[Docket No. FAA-2012-0060; Directorate Identifier 2012-NE-02-AD; Amendment 39-17123; AD 2012-14-09]

#### Airworthiness Directives; Pratt & Whitney (P&W) Division Turbofan Engines

**SUMMARY:** We are adopting a new airworthiness directive (AD) for certain P&W PW4000 series turbofan engines. This AD was prompted by reports of 3rd and 4th stage vane fractures in the low-pressure turbine (LPT) of certain PW4000-94" and PW4000-100" turbofan engines. This AD requires dimensional inspections of LPT 3rd stage vanes and the rear turbine case, inspection of LPT 4th stage vanes at the next LPT overhaul and removal of vanes with non-conforming airfoil fillet radii and vanes with more than one strip and recoat repair. This AD also requires disassembly and reassembly of the 2nd stage high-pressure turbine (HPT) rotor and 3rd stage LPT rotor at the next HPT and LPT overhauls. We are issuing this AD to prevent 3rd and 4th stage vane fractures in the LPT, damage to the LPT rotor, uncontained engine failure, and damage to the airplane.

Figure 1 to Paragraph (e) - Determination of Vane Eligibility

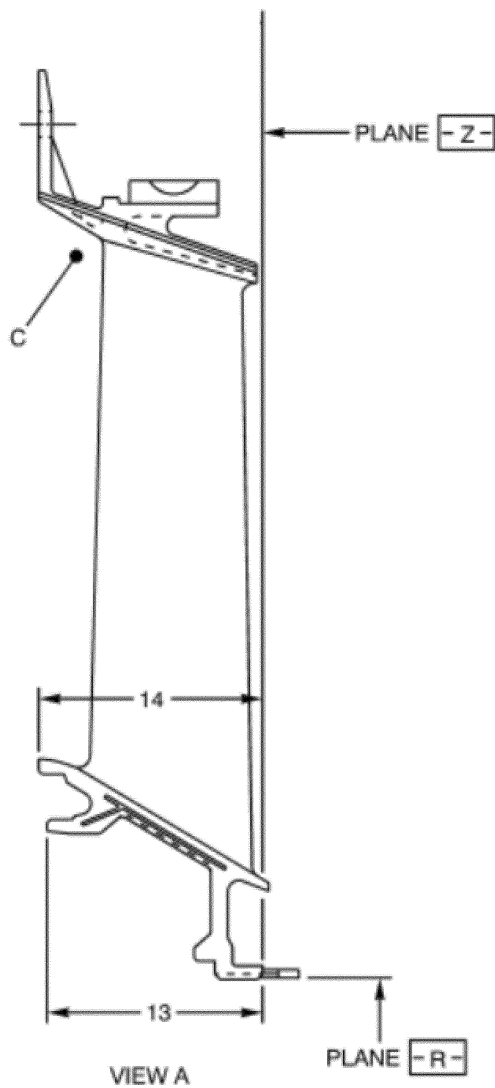
United Airlines requested that in proposed AD paragraphs (e)(1)(iii) and (e)(1)(iv), we change "ensure adequate engagement" to "dimensionally inspect the applicable LPT case slot serviceable dimensions and 3rd stage vane serviceable dimensions per the appropriate CIR." The commenter also requested that we list the specific dimensions to inspect by index number. The commenter stated that no mechanic can deduce what an adequate engagement is because it is not specific enough.

We agree. We changed paragraph (e)(1)(iii) to "dimensionally examine index 13 through index 34 of the LPT 3rd stage vane cluster assembly." We also changed paragraph (e)(1)(iv) to "dimensionally examine index 23 and index 24 of the vane engagement slots on the rear turbine case, where the 3rd stage vane is installed." We also listed the specific dimensions to inspect by index number, and included the supporting figures in this AD.

(iii) Dimensionally examine index 13 through index 34 of the LPT 3rd stage vane cluster assembly. Use Table 2 to paragraph (e) of this AD and Figure 1, Figure 2, and

Figure 4 to Paragraph (e) - Determination of Case Eligibility

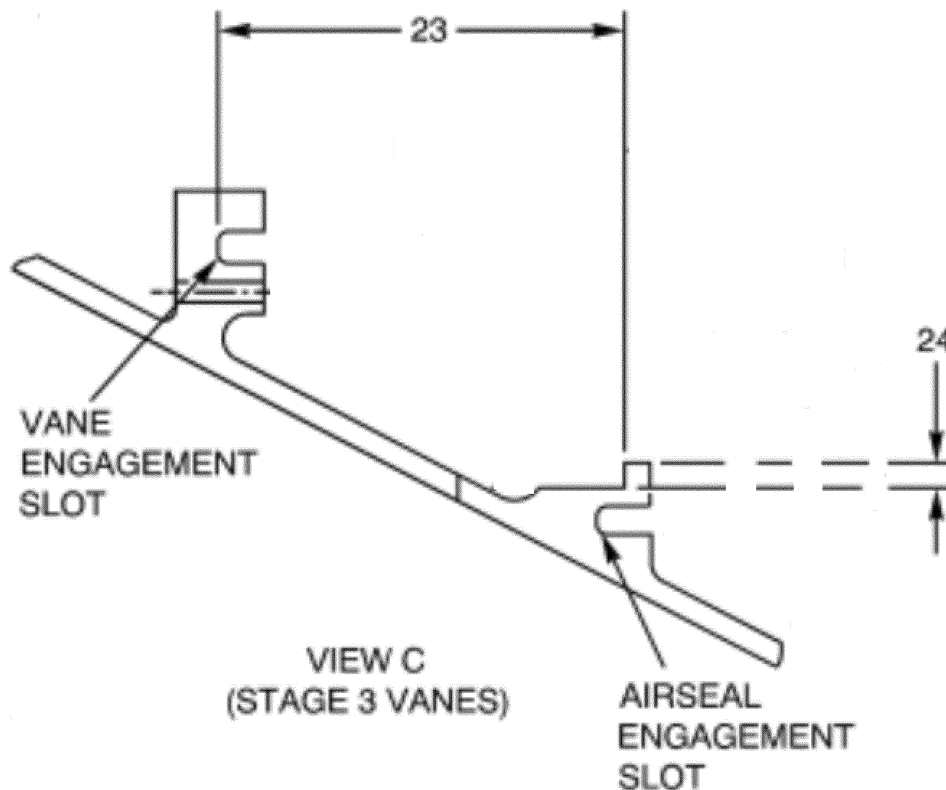
United Airlines requested that in proposed AD paragraph (e)(1)(iv) we make the CIR inspections more specific for the LPT case dimensions. The commenter stated that there are different ways to perform the measurements and it is not clear whether the dimension to measure is based on an average or an individual diametric dimension.

We do not agree. A specific measurement technique is not defined because multiple measurement techniques exist that are acceptable. The only diametric dimensional inspection required by the AD is index 24, which would be acceptable to measure based

(iv) Dimensionally examine index 23 and index 24 of the vane engagement slots on the rear turbine case, where the 3rd stage vane is installed. Use Table 3 to paragraph (e) of this AD and Figure 4 to paragraph (e) of this AD to determine whether the case is eligible for installation.
